Strålsäkerhetsmyndigheten

Technical Note

2012:18

SR-Site Independent Modelling of
Engineered Barrier Evolution and
Coupled THMC: Contribution to the
Initial Review Phase

Figure 3 Applied water filter pressure and measured inflows of water in the CRT experiment.

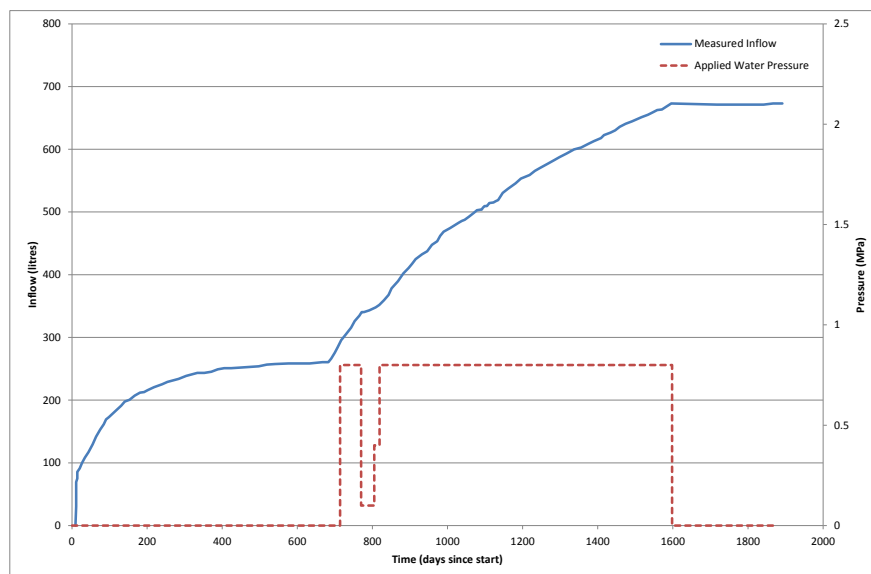
Due to the uniformly-applied boundary conditions on the deposition hole in the CRT test, the maximum distance over which the water in the CRT model had to be 'pulled' is equal to the radius of the deposition hole. The data suggests that the suction pressure that was exerted alone was insufficient to provide this distance of travel. In a deposition hole that is being resaturated from one or two small fractures, water will be less readily available and will have to be pulled over greater distances vertically in the deposition hole, potentially equal to the height of the canister. The

CRT data does not necessarily suggest that this will be possible without an external driving force for the flow, and so it may be possible for hypothetical situations like the one depicted in Figure 4 to arise. Here, the suction pressure (and water pressure at the fracture intersect) has been supposed to be insufficient to draw the water across the entire buffer, or that at least the rate at which water can be pulled into the buffer is slow. An equilibrium, or long-lived situation then arises in which a fully saturated region has developed near the fracture and up to the canister surface, whilst overall the buffer is not resaturated. The consequence is that the swelling pressure in the buffer could remain close to emplacement swelling pressures in some locations, whilst reaching the desired resaturated swelling pressures in others. It is stressed that this is a hypothetical situation and no evidence is present to suggest that it will occur, but equally the evidence from the CRT test would not appear to rule out such a possibility.

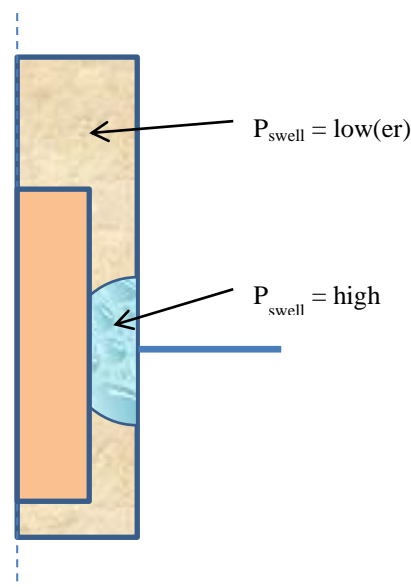
As was noted above, SKB have no performance requirements for an unsaturated buffer, but this treats saturation as a ‘black and white’ issue. If the self-limiting behaviour that has been referred to above is genuine, or if behaviour of this type only acts to slow the rate of resaturation, then it is possible that there could be a long time period over which the saturation in the buffer has a pattern similar to that sketched in Figure 4. If this situation were to occur then the following consequences could apply:

SKB also acknowledge incomplete understanding of how the mechanical behaviour of the bentonite may affect its ability to resaturate under conditions of limited water supply when they state (**THM modelling report** (TR-10-11), page 372) that “The relation between the saturation responses for TH-models and Thermo-Hydro-Mechanical (THM)-models has only been investigated for rapid saturation processes”. It is suggested that further investigation of this behaviour may help to understand whether situations like the one sketched in Figure 4 are possible.

Figure 5 Figure 10-50 from TR-11-01 showing the predicted times for resaturation for various scenarios.

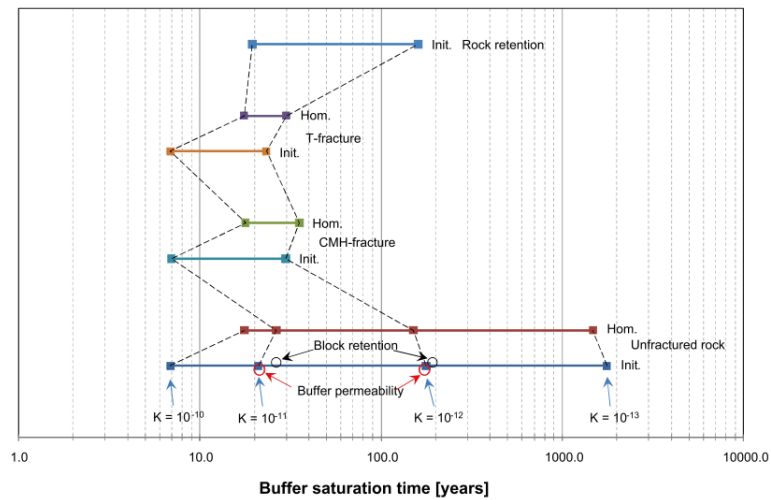
One surprising aspect of the results that are presented in Section 3 of TR-10-11 is that the minimum time taken for complete resaturation is around 7 years and that the predicted times for complete resaturation of the buffer from a canister mid-height fracture are only in the range 7-30 years (Figure 5, which is a reproduction of TR-10-11, Figure 10-50). Here, “complete resaturation” is defined as porewater saturation being greater than 0.99 at every location in the model of the buffer. This result appears to be inconsistent with the measured saturations in the uniformly-wetted CRT test after 5.5 years (Section 6). These measurements suggested that not even the bentonite rings up to the canister surface had been fully resaturated in this time. Resaturation over the longer distances to the centres of the bentonite cylinders above the canister would seem unlikely.

It would be useful to hear SKB’s comments on this observation and to see the estimated time for resaturation if the TH models were applied to the CRT data.

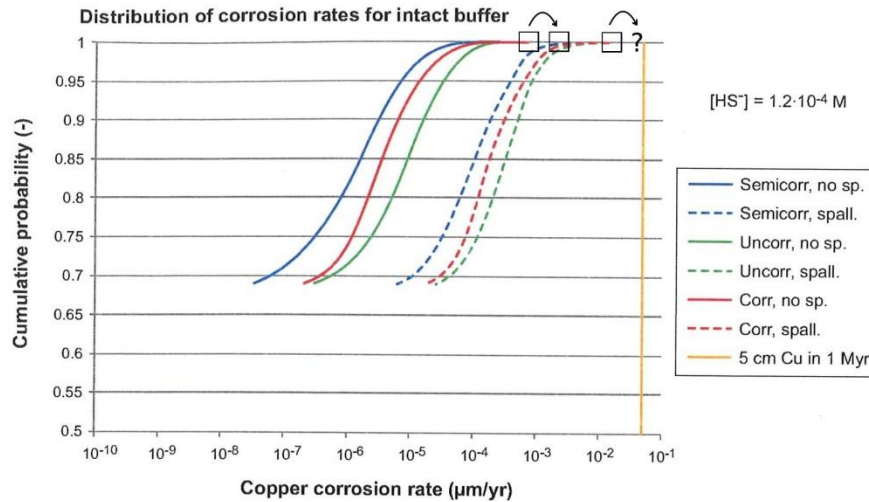
For example, Figure 10 shows the distribution of corrosion rates for the different geological DFN models calculated using the Q_{eq} approach (TR-10-66 / Fig 5-4). Superimposed on the plot are new datapoints corresponding to the results shown in Figure 8 and Figure 9. With the fracture assumed to be at the canister mid-height and with no spalling, the extremal value of the SKB distribution is attained for this choice of parameters (maximal sulphide concentration of 1.2×10^{-4} mol/kg and a fracture aperture of 1mm). For the same choice of parameters but with the fracture assumed to be at the canister top, the extremal value of the distribution is exceeded.
